# Venice Neighborhood Council

## Land Use & Planning Committee (LUPC) STAFF REPORT

<b>City Case No:</b>	<b>DIR-2025-6828-CDO</b>
<b>CEQA Case No:</b>	<b>ENV-2025-6829-CE</b>
<b>Related City Case No(s):</b>	
<b>Address of Project:</b>	<b>2454 Lincoln Blvd</b>
<b>Applicant/Property Owner:</b>	<b>Applicant: Sun Day Carwash; Property owner of Record: Lincoln Millennium Car Wash, Inc.</b>
<b>Applicant's Representative:</b>	<b>Adan Madrid, 7 Planning Construction and Development, Inc.</b>
<b>Standard of Review:</b>	<b>Lincoln Boulevard Community Design Overlay; Venice Community Plan CEQA categorical exemption (Class 1 Existing Facilities)</b>
<b>Coastal Zone:</b>	<b>N/A</b>
<b>City Hearing:</b>	<b>Director's Determination issued March 23, 2026; last day to appeal April 7, 2026</b>
<b>Email for City Planner:</b>	<b>Sienna.Kuo@lacity.org</b>
<b>LUPC Staff assigned:</b>	<b>Nicole Meyer</b>

**PLANTING LEGEND**

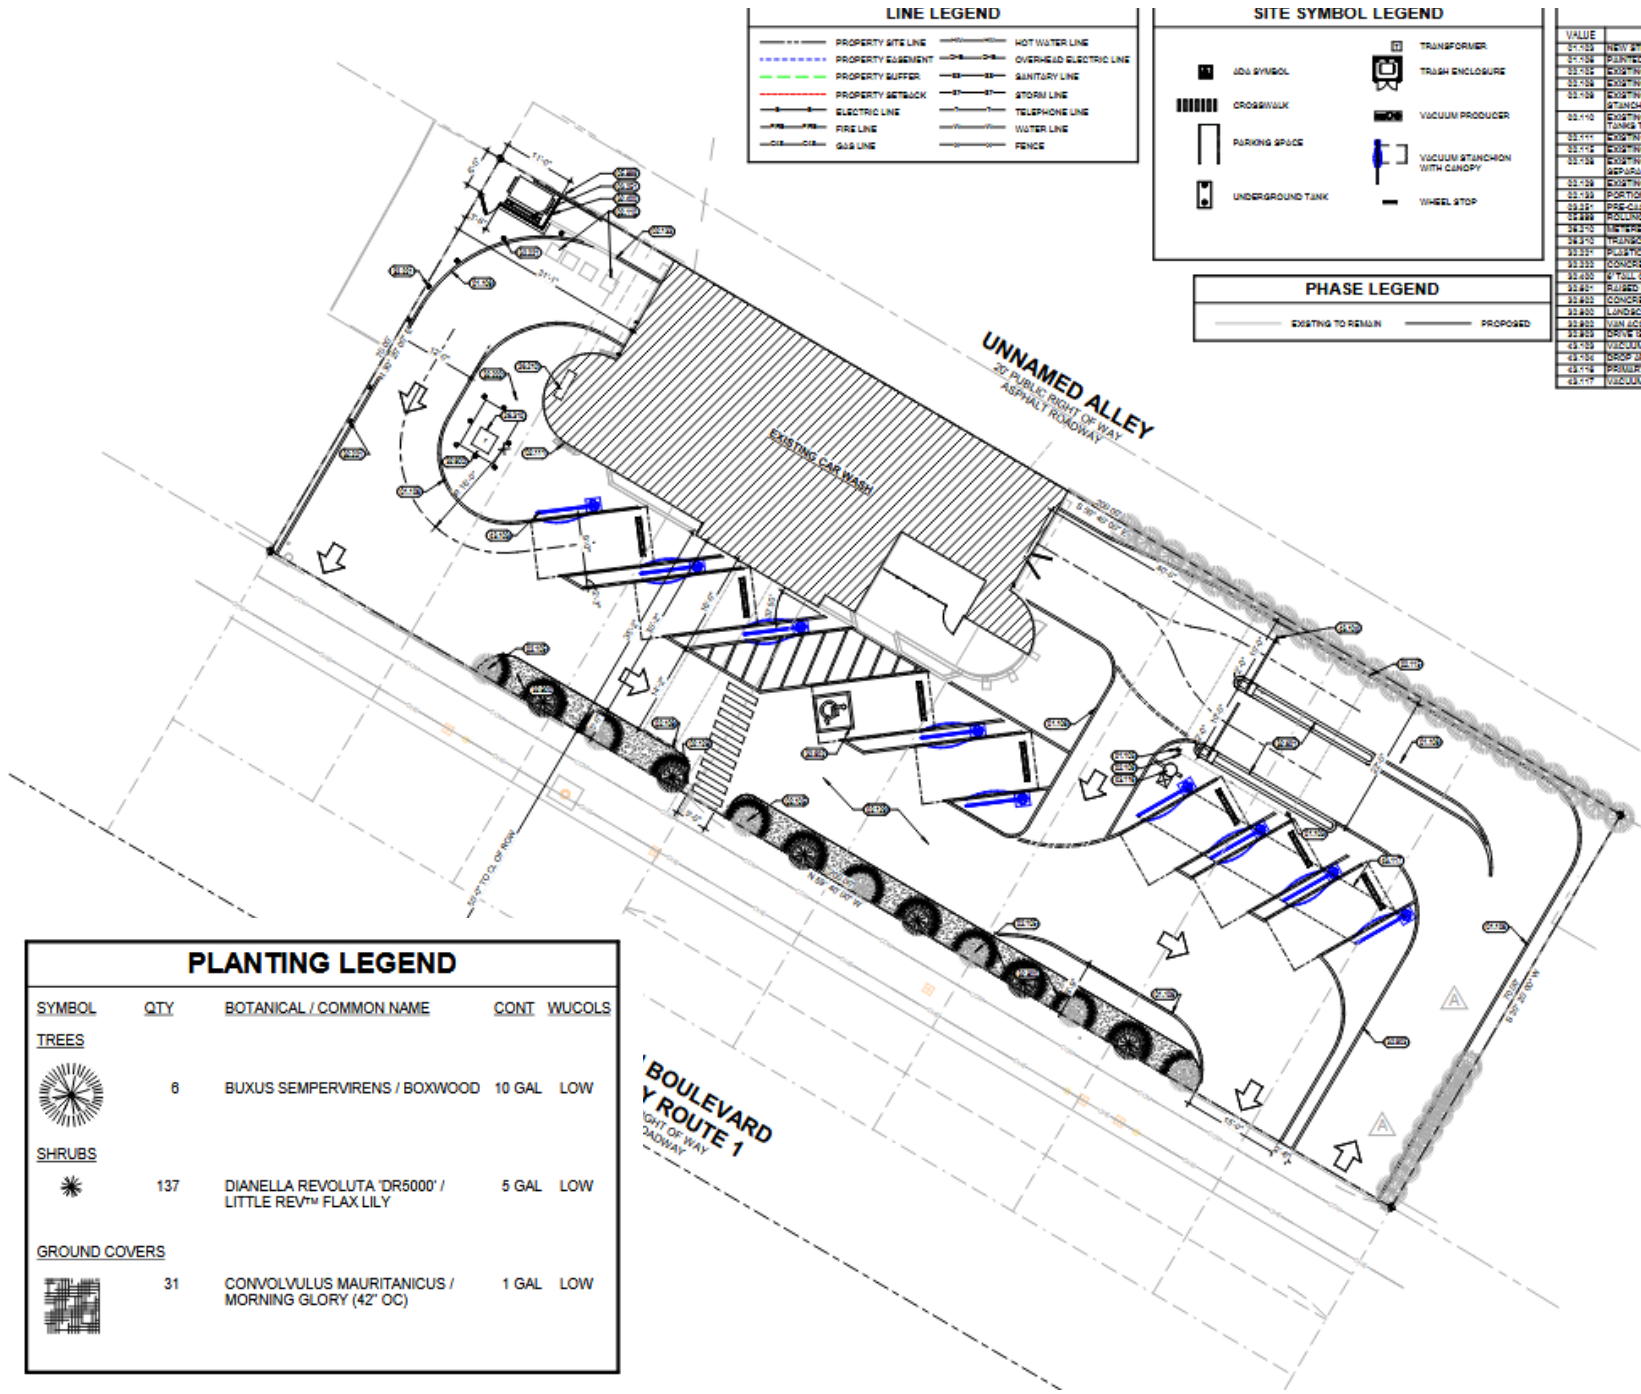
**The Venice Neighborhood Council supports the approval of the project and, with respect to the landscape plan, requests planting of small native trees such as Toyons (as they are smaller and grow fast), planting of native shrubs such as Ceonothus Aboreus, and planting of ground cover such as Yarrow.**
